Bayside Planning Panel

Item No	6.2
Application Type	Alterations and additions and first floor addition to semi detached dwelling
Application Number	2017/1120
Lodgement Date	13 September 2017
Property	63 Dougherty Street, Rosebery Lot 51 in DP 226188
Owner	Warwick Bruce Dickinson & Rebecca Mary Vassel
Applicant	Warwick Bruce Dickinson
Proposal	Alterations and additions to an existing semi-detached dwelling, comprising ground floor alterations and additions, a new first floor addition and a carport.
No. of Submissions	One (1) objection to amended plans
Cost of Development	\$250,000.00
Report by	Andrew Ison – Consultant Planner

Supplementary Planning Assessment Report

Assessment of the Panel's deferment

Figure 1. Amended streetscape elevation plans

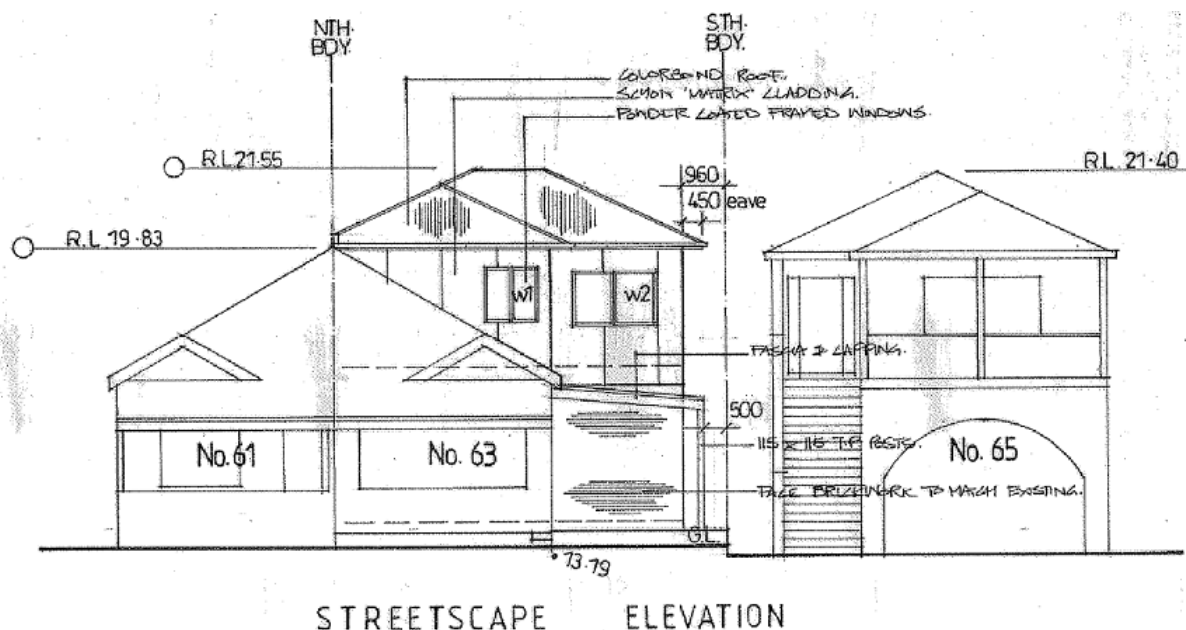
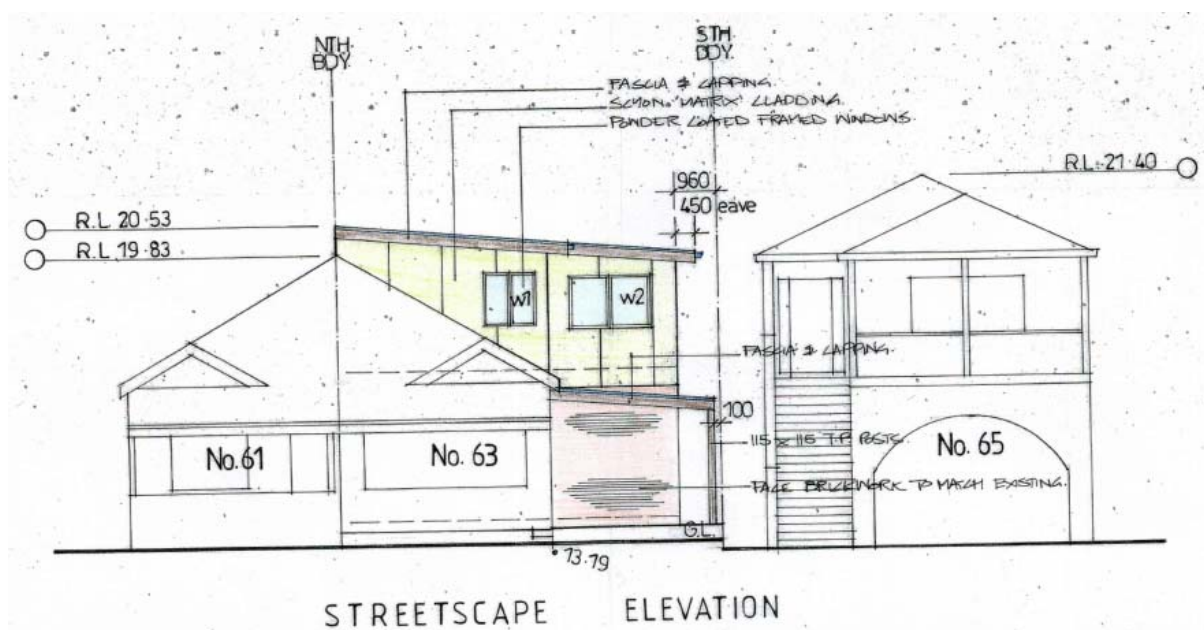
1. *The form of the extension in terms of its architectural language and details in particular with respect to the roof form and fenestrations to provide a better relationship with the existing semi-detached dwelling in the streetscape including the relationship with the adjoining semi.*

The amended plans presents a proposal which has increased the height of the building from a maximum of 7.05m above the natural ground level up to 7.79m. However, it remains compliant with the Height of Building development standard of 9m that is prescribed for the subject site.

Additionally, we have noted that the structure has increased in height as a result of the change in the roof form from skillion to pitched roof. We do not have an issue with the roof form however Council will need to guarantee that the neighbouring sites can still receive the minimum 2 hours solar amenity.

The applicant has submitted amended elevational shadow diagrams which have been assessed against the solar access controls as prescribed under Part 4A.4.3 of the DCP. These plans indicate that the first floor kitchen window at No. 65 Dougherty Street to the immediate south, will be in shadow at 9:00am and will then receive direct sunlight from 12 noon through to 3:00pm.

Figure 14: Proposed Elevational Shadows at Midday and 3pm in Mid-winter Source: Peter Banfield, August 2017

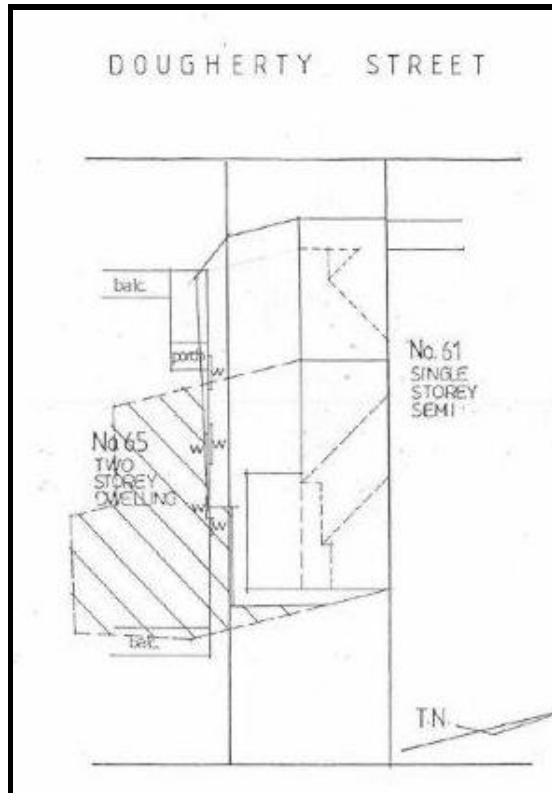
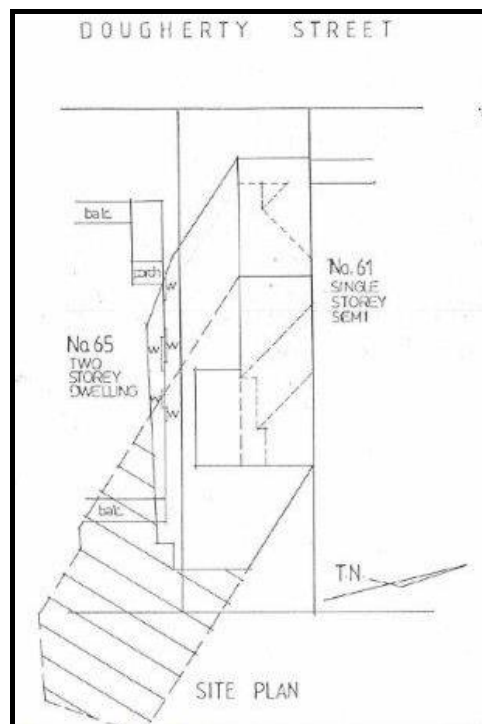
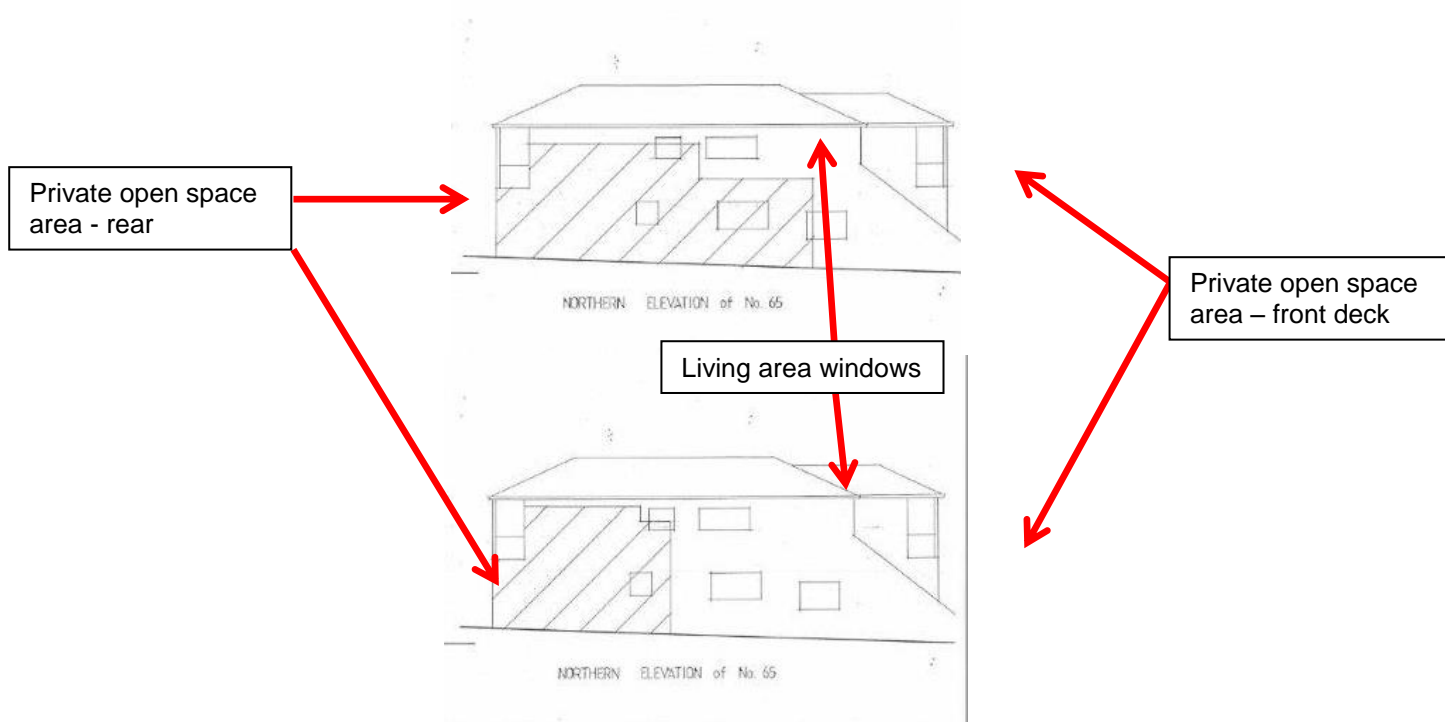
property (No 65 Dougherty Street) as outlined Table 3. The applicant provided the relevant shadow diagrams and elevational shadow plans which demonstrate this (refer figures below). The front and rear private open space areas with balconies will receive adequate solar access throughout the day. The front area receives solar access in the afternoon while the rear open space receives solar access in the morning during mid-winter.

In relation to the living area windows, it is considered that these windows are likely to be those directly behind the front balcony area towards the front of the dwelling which will receive sunlight from midday in mid-winter. The other living areas are considered to be directly adjoining the rear private open space area which does not contain windows on the northern elevation. It is considered that adequate solar access, in accordance with the BBDCP 2013 controls is achieved by the adjoining southern property as demonstrated below.
